AREA WALK-BY CHECKLIST

IP2

Area Walk-By Checklist (AWC) AWC-013

Location: Bldg. SWSTR PIT Floor El. 5'-9" Room, Area¹ Zem Strainer Pit

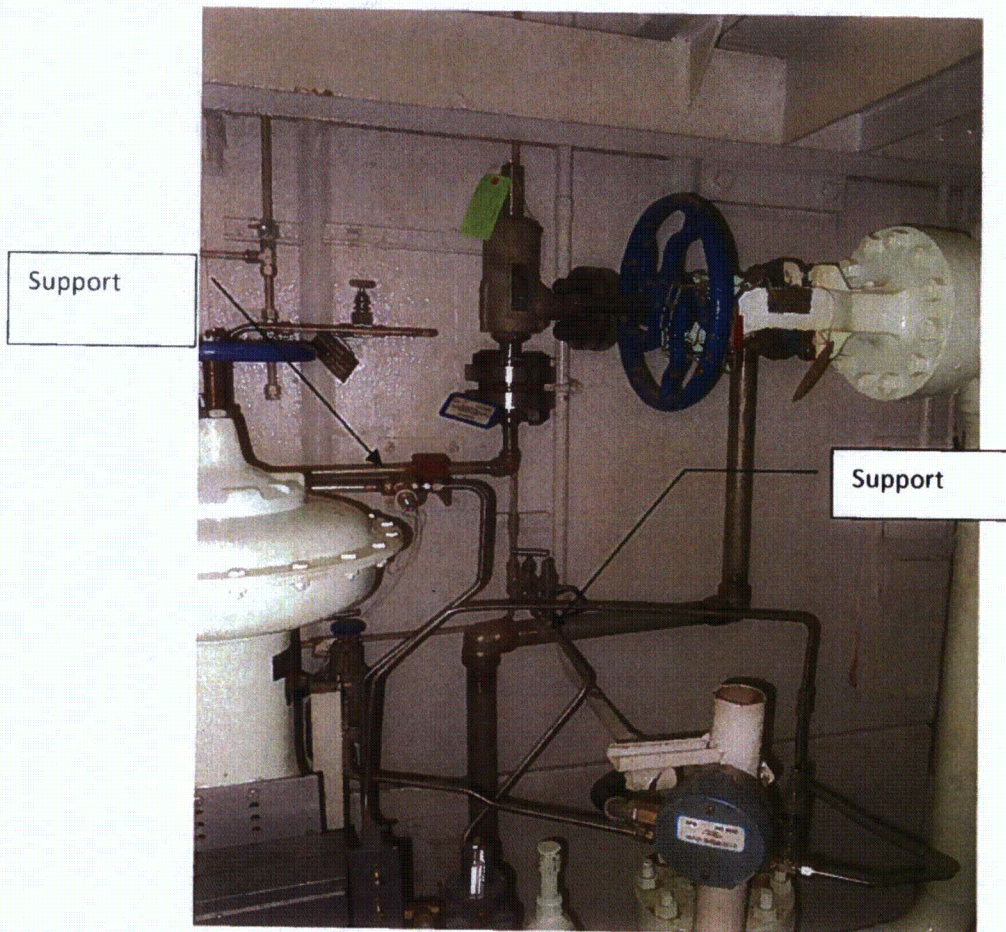
A picture of the piping, located at the southern end of the AFB Elev. 18'-6", is provided below:

A subsequent walkdown of the pipe location by members of the IPEC Design Engineering Department certified for performance of the Seismic Walkdowns, assessed the configuration and found that: (1) spans are not excessive for the 2 3/4" diameter pipe, for which a span of 8'-0" would not be questionable, (2) the in-line loads are not excessive, and (3) the configuration is acceptable.

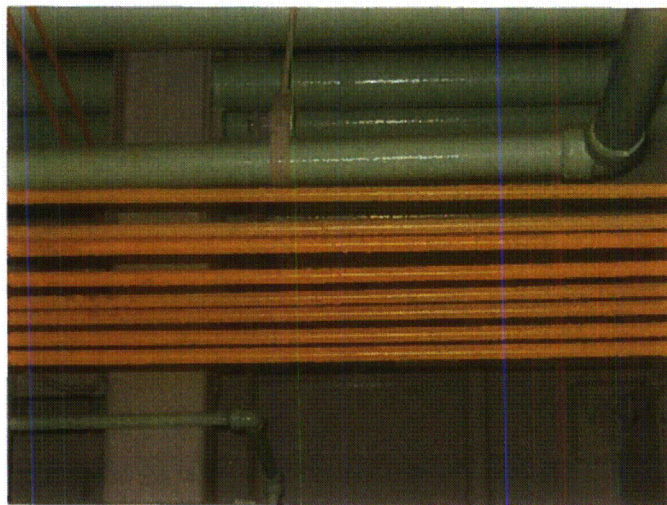
The Seismic Walkdown Team noted that Long span 5/8" OD" tubing has little separation and typical span length of eight feet .The tubes will interact with each other during seismic event. There are also 3/8" OD tubes also in close proximity to each other which have similar unsupported spans. Photographs of the tubing configurations, contained in AWC-35 are provided below:
